BULLETIN: 25953

Front Coil Springs Breaking

1998–2000 Ford Contour and Mercury Mystique

MOOG® Coil Springs 80160 and 80162

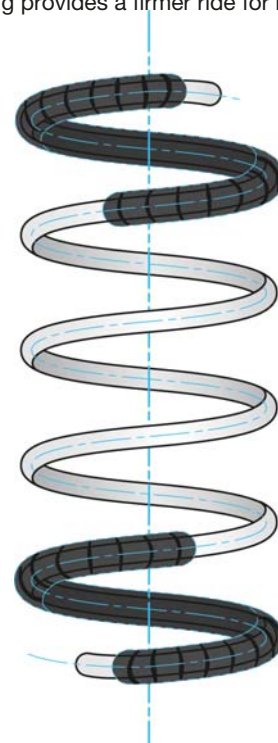
- Front coil springs for the Ford Contour and the Mercury Mystique from 1998 to 2000 could potentially fracture due to corrosion and fatigue. Tires can be punctured by coming in contact with a broken spring.

- MOOG offers a replacement, constant rate coil spring that is designed to provide more strength and durability.
- Creates lower stress throughout the spring to resist fatigue due to a larger diameter bar and a higher spring rate.
- Incorporates a shorter free height.
- Resists corrosion with an improved, coated material.
- Resists spring clash with a plastic sleeve.
- Tougher spring provides a firmer ride for better handling.
